SOLICITATION AMENDMENT
MODIFICATION DE L'INVITATION

Title - Sujet Travaux d'aménagement - Édifice Jea	
Solicitation No. - N° de l'invitation ED001-160389/A	Amendment No. - N° modif. 003
Client Reference No. - N° de référence du client R.061033.001	Date 2015-07-09
GETS Reference No. - N° de référence de SEAG PW-\$PWC-006-3653	
File No. - N° de dossier PWC-5-38032 (006)	CCC No./N° CCC - FMS No./N° VME
Solicitation Closes - L'invitation prend fin at - à 02:00 PM on - le 2015-07-14	Time Zone Fuseau horaire Atlantic Daylight Saving Time ADT
F.O.B. - F.A.B. Plant-Usine: <input type="checkbox"/> Destination: <input checked="" type="checkbox"/> Other-Autre: <input type="checkbox"/>	
Address Enquiries to: - Adresser toutes questions à: Martin, Lisa	Buyer Id - Id de l'acheteur pwc006
Telephone No. - N° de téléphone (506) 851-7811 ()	FAX No. - N° de FAX (902) 566-7514
Destination - of Goods, Services, and Construction: Destination - des biens, services et construction:

Addenda numéro 3

MAIN FLOOR PLAN ZONE A ELECTRICAL DOOR CONTROL ZONE 1 & 2		drawing design date
designed E.S.C. P.ENG/AD.J., P.ENG date 2015-06-11 drawn M.E.M., C.E.T. date 2015-06-11 approved date tender PWSGC Project Manag

MAIN FLOOR PLAN - ZONE A SECURITY - ZONE 1 & 2

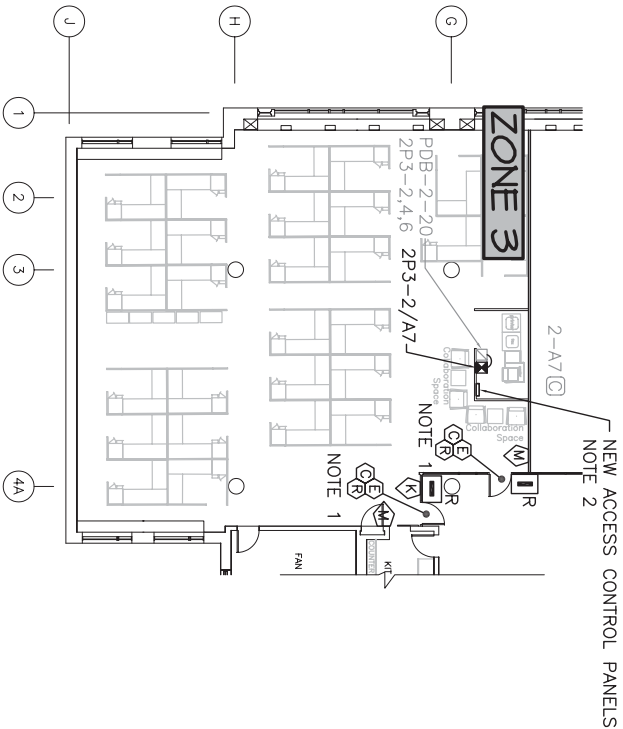
REMOVE all reference to sketches SK-1, SK-2, SK-3 and SK-4 and **REPLACE WITH** the revised attached sketches SK-1, SK-2, SK-3 and SK-4.

1. SUPPLY AND INSTALL WIRING FROM SECURITY AND ACCESS CONTROL DEVICES TO NEW CONTROL PANEL IN MAIN FLOOR MAIL ROOM. DEVICES TO BE SUPPLIED AND INSTALLED BY ALLIANCE SECURITY UNDER THIS CONTRACT. REFER TO SK-4 FOR WIRING DETAILS.
2. CLOSED CIRCUIT VIDEO EQUIPMENT SYSTEM AND ALL CABLING TO BE RELOCATED BY CHUBB SECURITY UNDER THIS CONTRACT.
3. ACCESS CONTROL PANEL TO BE SUPPLIED AND INSTALLED BY ALLIANCE SECURITY UNDER THIS CONTRACT. FIVE ACCESS CONTROL PANEL AND PC TO BE RELOCATED FROM 161 ST. PETER'S RD, CHARLOTTETOWN.
4. LEAVE EXISTING ACCESS CONTROL WIRING COILED AND LABELED IN ACCESSIBLE FLOOR SPACE FOR FUTURE RECONNECTION. ARRANGE FOR EDWARDS TO DECOMMISSION EXISTING DOOR CONTROLS. COORDINATE SCHEDULES SO DOORS ARE NOT LEFT UNSUPERVISED.

SECOND FLOOR PLAN - ZONE B SECURITY - ZONE 3

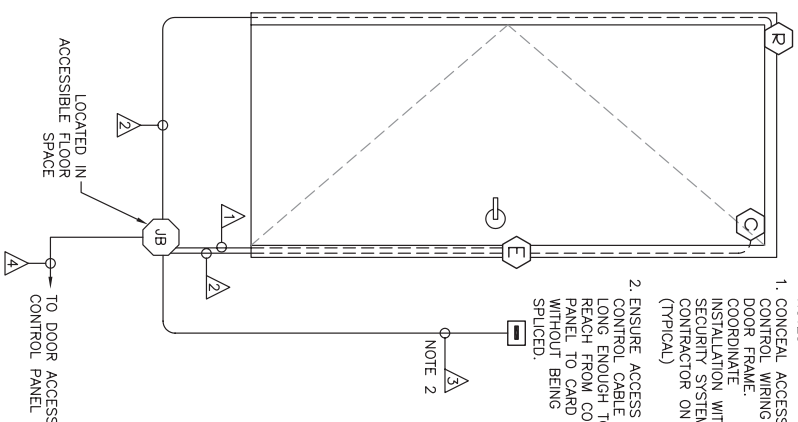
- NOTES
1. SUPPLY AND INSTALL WIRING FROM SECURITY AND ACCESS CONTROL DEVICES TO NEW CONTROL PANEL IN SHARED EQUIPMENT ROOM. DEVICES TO BE SUPPLIED AND INSTALLED BY ALLIANCE SECURITY UNDER THIS CONTRACT. REFER TO SK-4 FOR WIRING DETAILS.

- ACCESS CONTROL PANEL TO BE SUPPLIED AND INSTALLED BY ALLIANCE SECURITY UNDER THIS CONTRACT.

- LEAVE EXISTING ACCESS CONTROL WIRING COILED AND LABELED IN ACCESSIBLE FLOOR SPACE FOR FUTURE RECONNECTION. ARRANGE FOR EDWARDS TO DECOMMISSION EXISTING DOOR CONTROLS. COORDINATE SCHEDULES SO DOORS ARE NOT LEFT UNSUPERVISED.

SECURITY & ACCESS CONTROL RISER DIAGRAM NTS

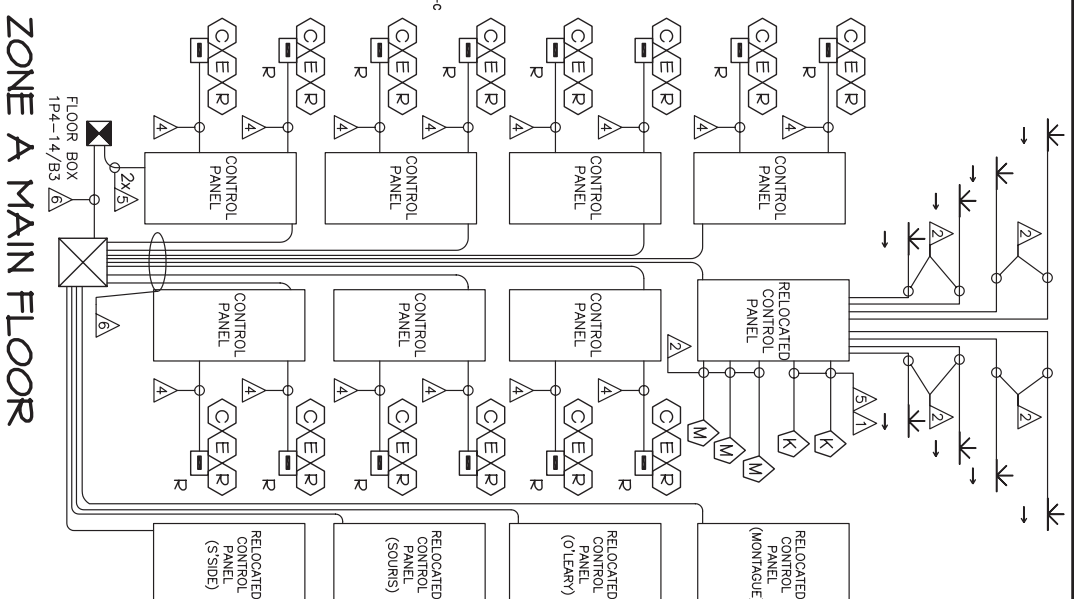
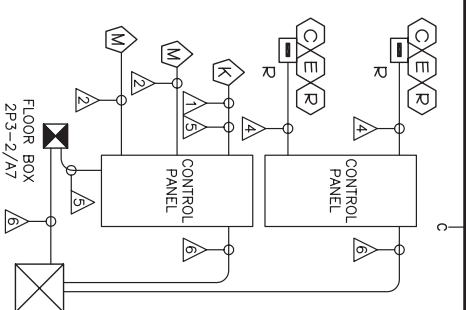
- NOTES
1. CONCEAL ACCESS CONTROL WIRING IN DOOR FRAME. COORDINATE INSTALLATION WITH SECURITY SYSTEM CONTRACTOR ON SITE. (TYPICAL)
 2. ENSURE ACCESS CONTROL CABLE IS LONG ENOUGH TO REACH FROM CONTROL PANEL TO CARD READER WITHOUT BEING SPLICED.
